Re: Minor Project Refinement No. 1 for the Gates 500 kV Dynamic Reactive Support Project

Gates 500 kilovolt (kV) Dynamic Reactive Support Orchard Substation Project CPUC Minor Project Refinement Form

SPCS NAD 83, CA Zone IV, US Ft.
Data Sources: CalTrans, ESRI, Fresno County, USDA.
F:\Projects\Gates\MXDs\PEA\MPR-1 Figure 2 051523.mxd

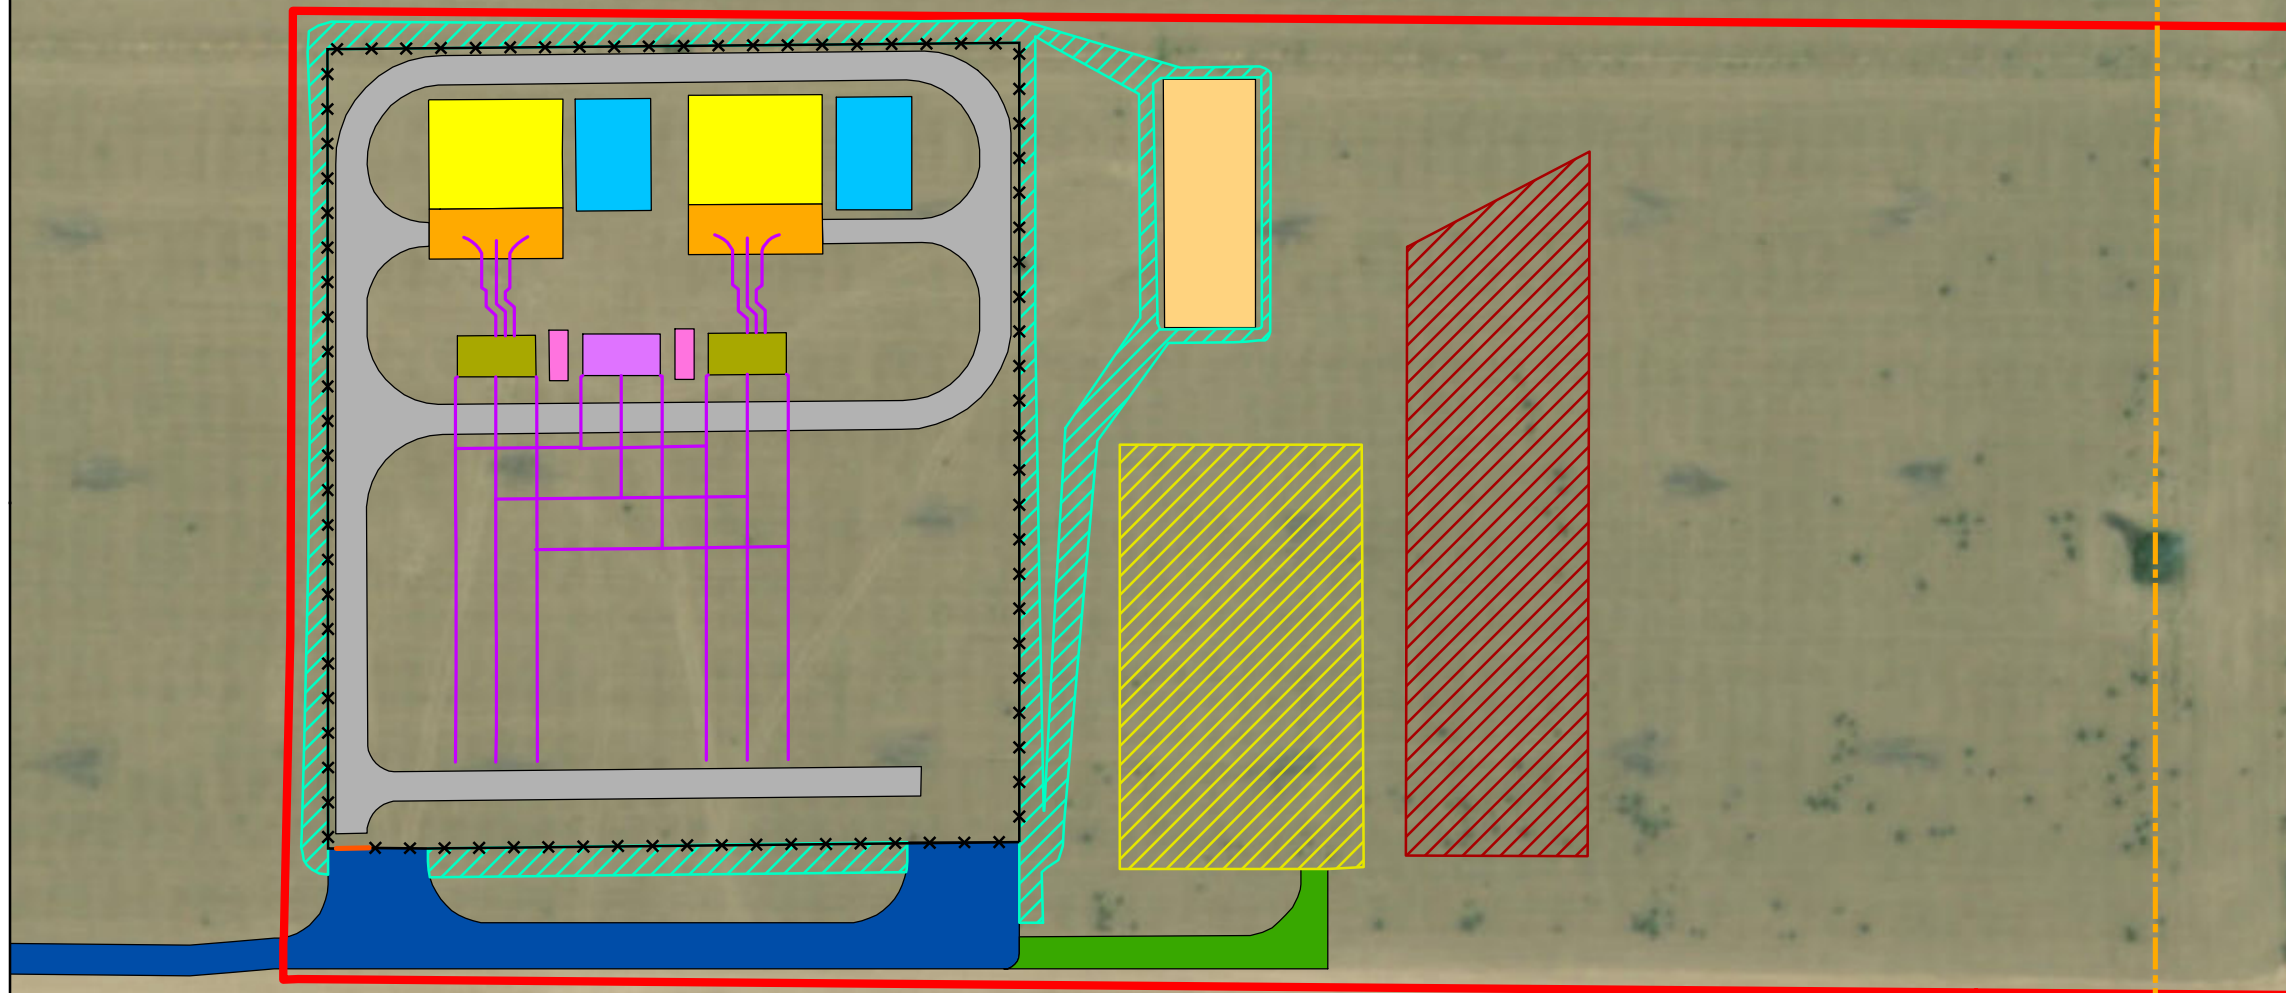
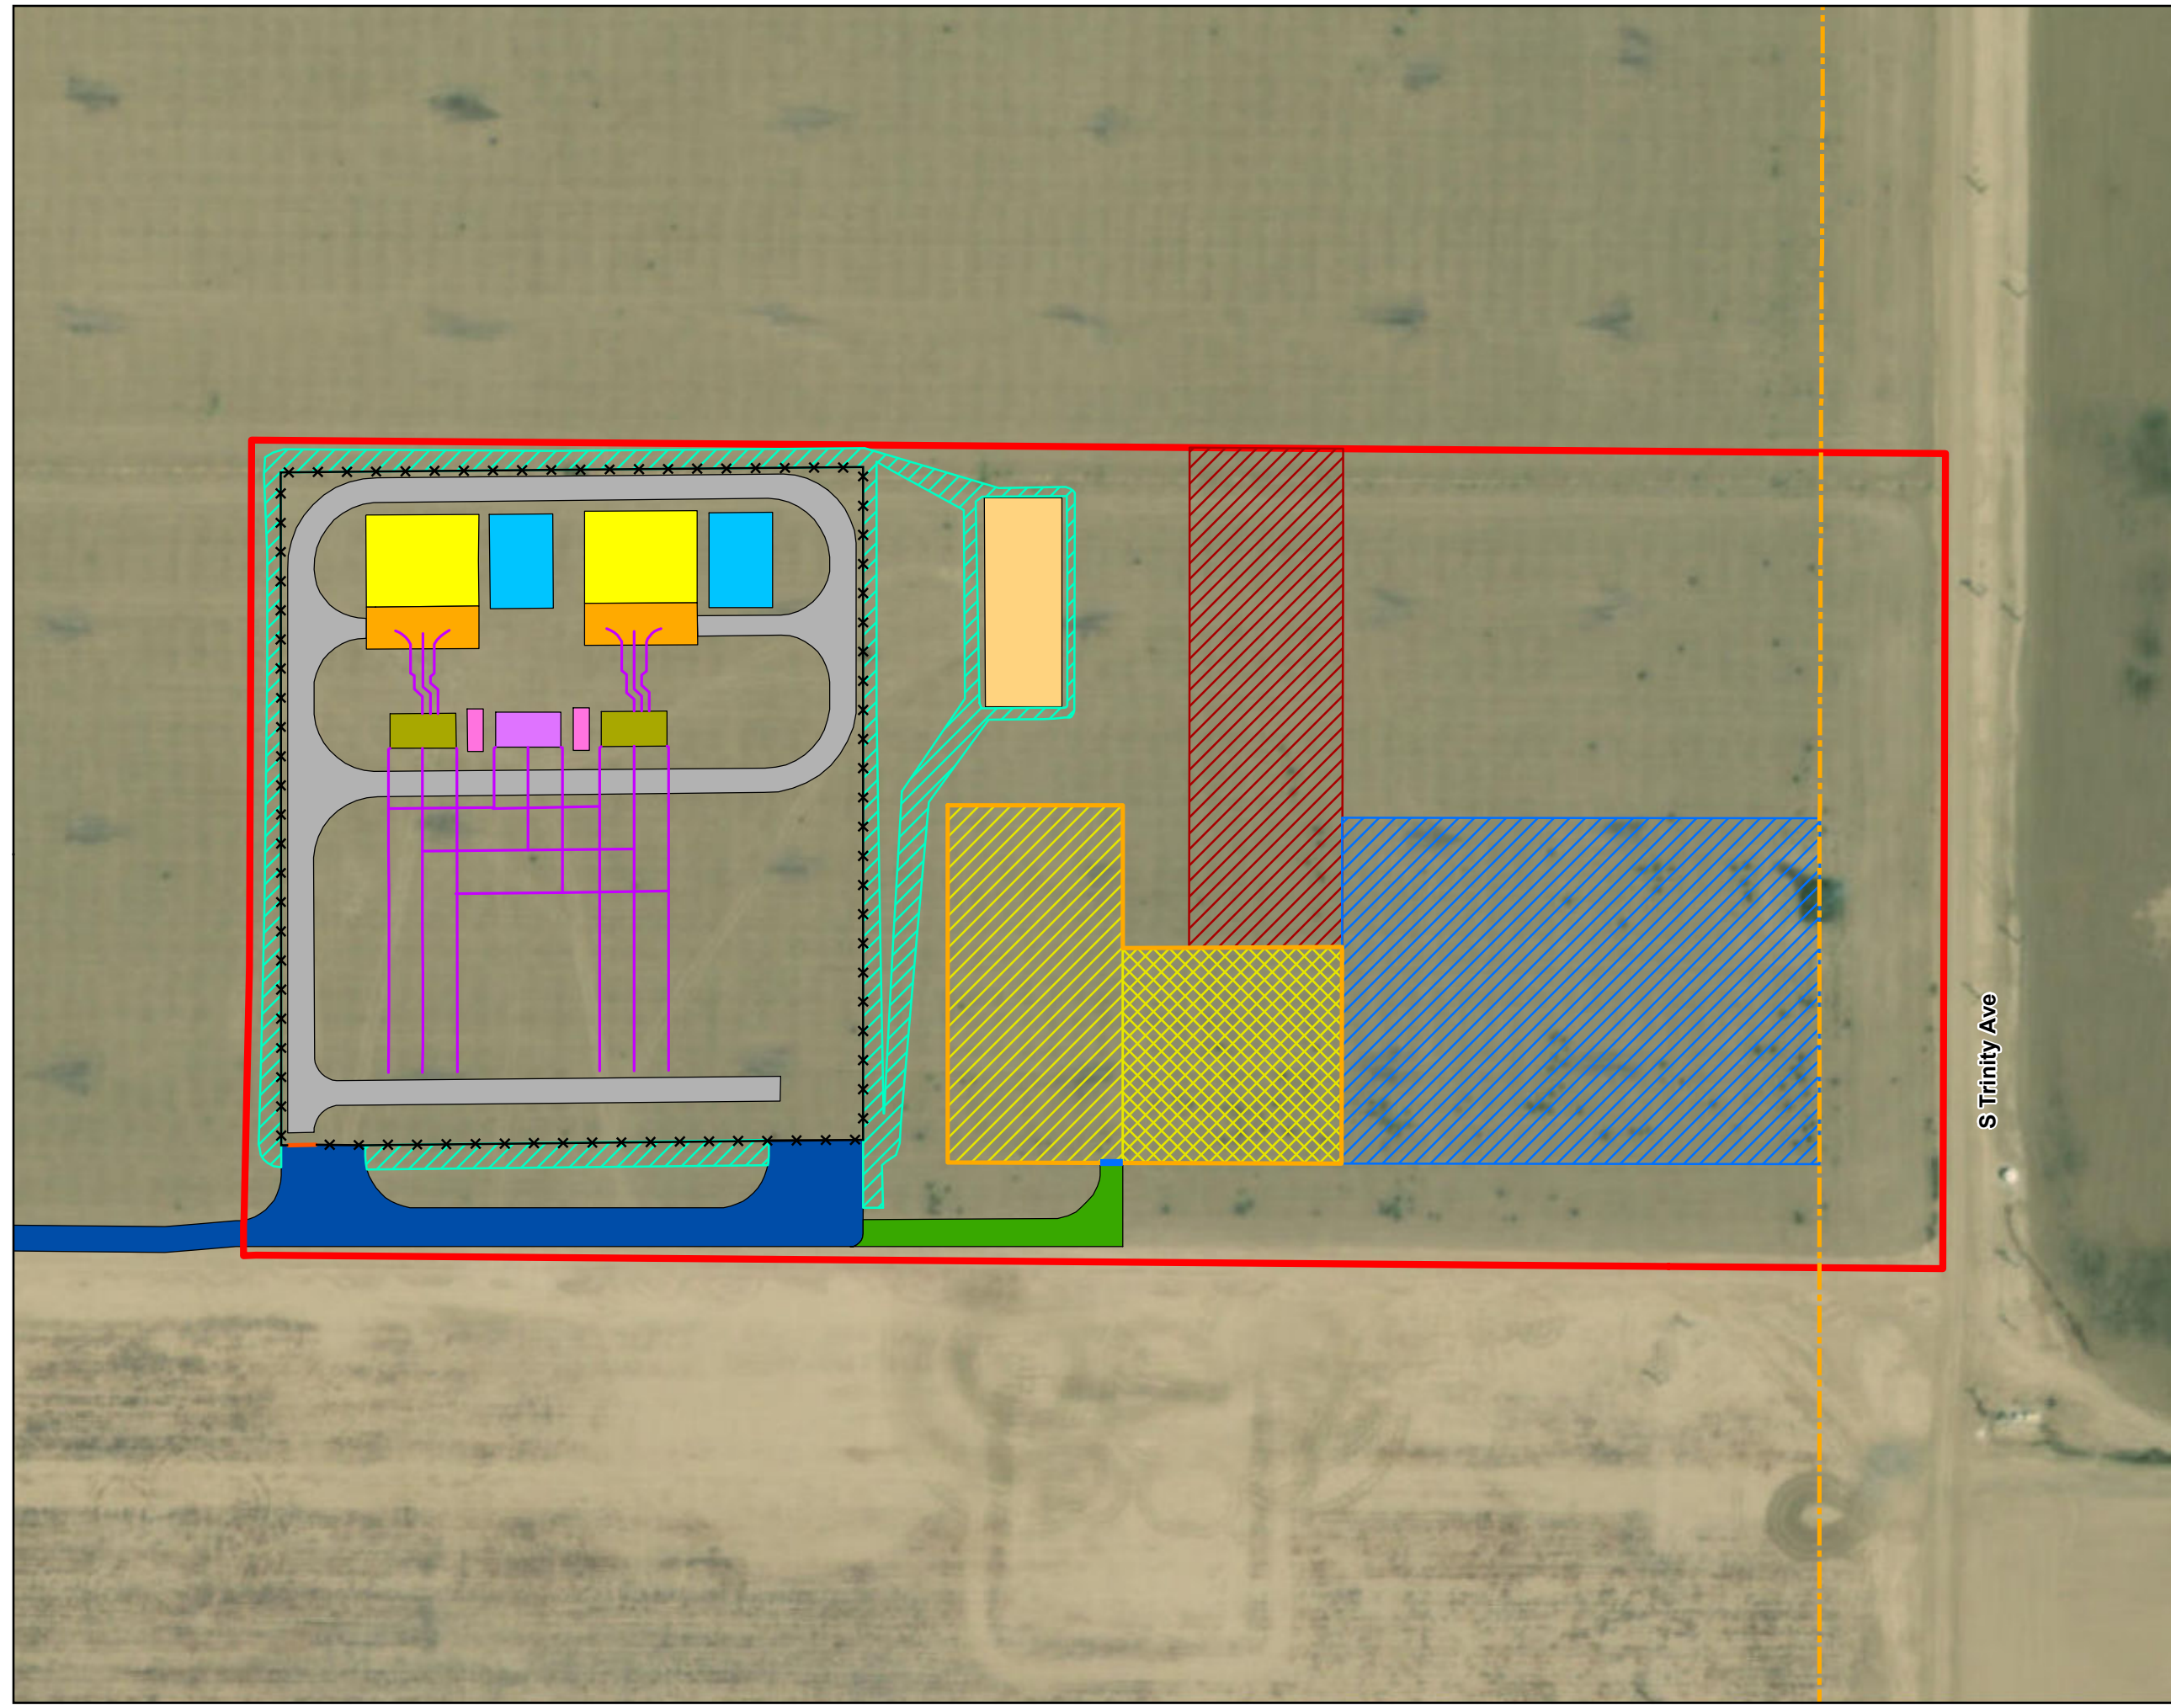
- The 160-foot by 160-foot staging area expansion. As described in the Project's approved Initial Study/Mitigated Negative Declaration (IS/MND), the staging area will be utilized as a refueling area for vehicles and construction equipment, equipment assemblage and storage, and parking for construction personnel. Security fencing will be installed around the perimeter of the staging area. Grading will take place as needed and gravel and base rock will be placed within the yard.

- The borrow area will be shifted approximately 160 feet north from its previous location (shown in the IS/MND). The borrow area would be used to build up the Orchard Substation pad and would be excavated to a depth of approximately 20 feet with an average slope of 3:1. The borrow area will be accessed via overland travel.
- Addition of a new temporary storage area east of the staging area which will be approximately 260 feet by 400 feet. The materials planned for storage within this work area are primarily substation components (stored on pallets) and topsoil. Temporary snow fence will be installed as needed to indicate the boundaries of the storage area, and no grading or placement of gravel is anticipated. The storage area will be accessed via overland travel.

The additional temporary work areas¹ resulting from MPR-1 will total approximately 118,100 square feet (2.7 acres). Please see **Attachment B, MPR-1 Figures** for an overview of the proposed changes in comparison to the work areas approved in the IS/MND. Following completion of Project construction, the MPR-1 temporary work areas would be restored to pre-construction conditions in compliance with APM AE-1 and the Stormwater Pollution Prevention Plan (SWPPP).

MPR-1 PHOTO LOG

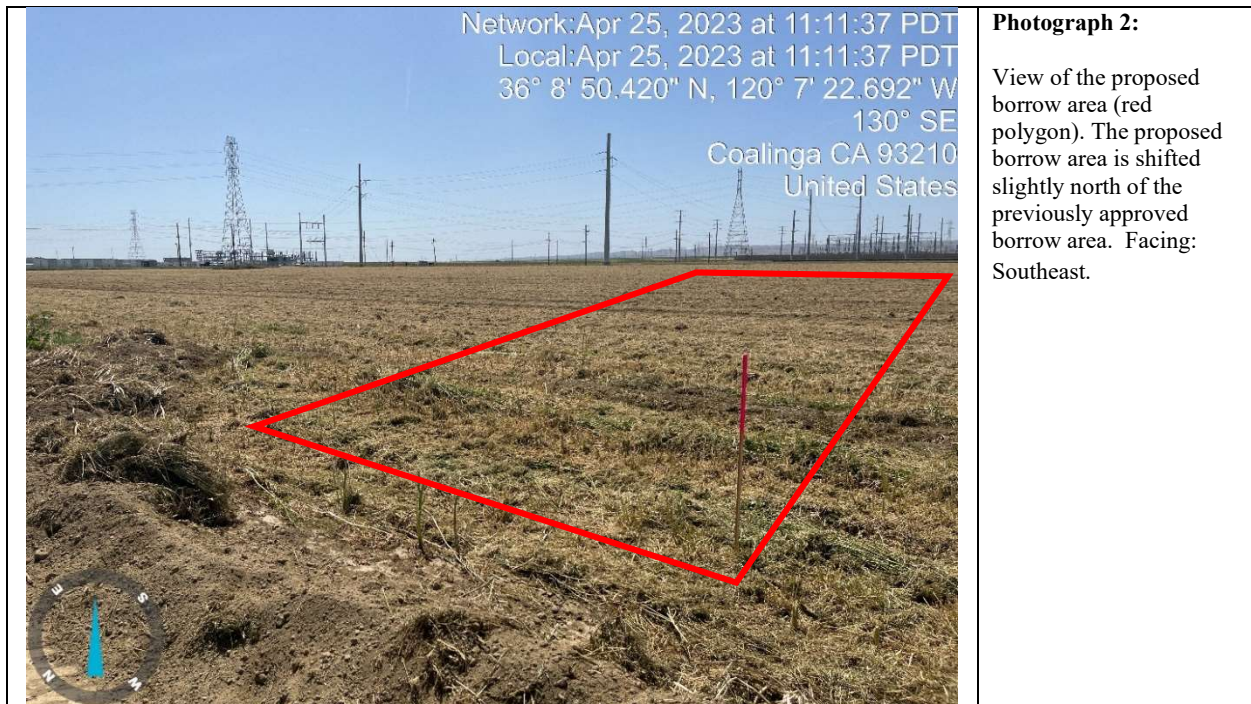
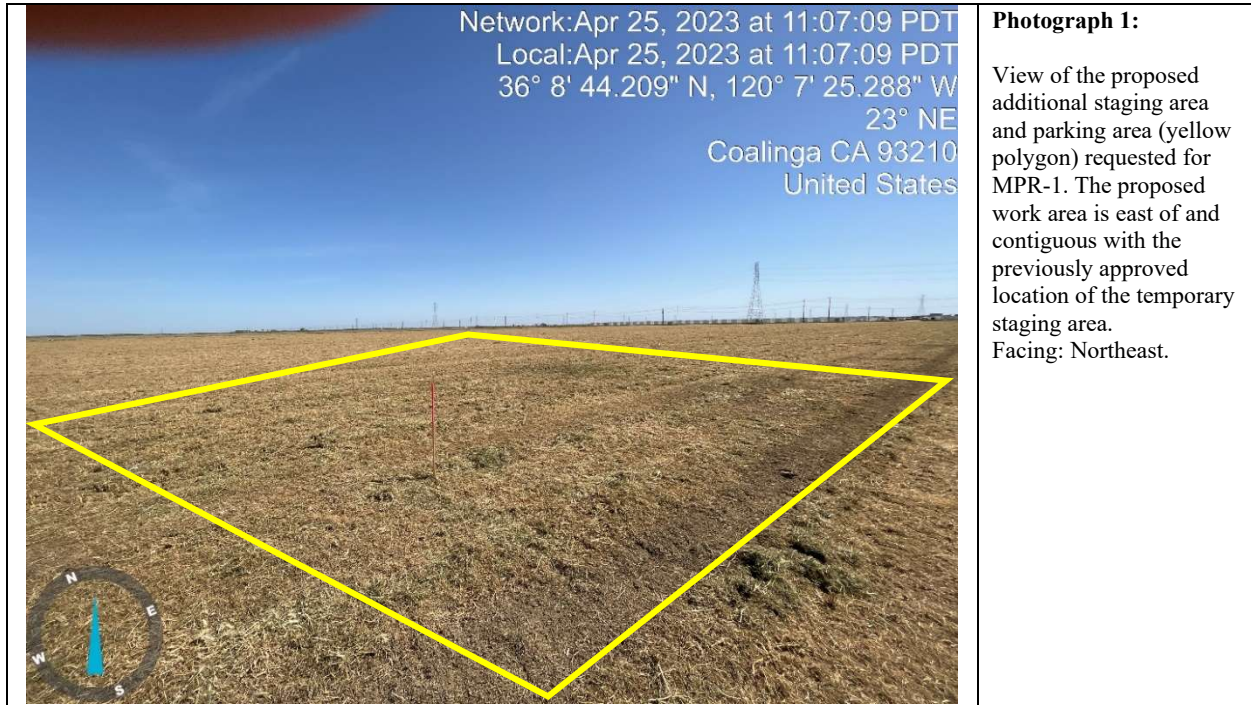
Maps & Figures: Refer to **Attachment B, MPR-1 Figures**, for a map of the proposed MPR-1 temporary work area locations. Refer to **Attachment C, MPR-1 Site Photographs**, for pictures of the current conditions within the MPR-1 temporary work areas. Although the Project site boundary in **Attachment B, MPR-1 Figures** appears to be modified from the boundary represented in Figure 2-1 in the IS/MND, no modifications have been made to the site boundary, and it remains unchanged from what was approved by the CPUC in the Permit to Construct, IS/MND and Notice to Proceed #1.
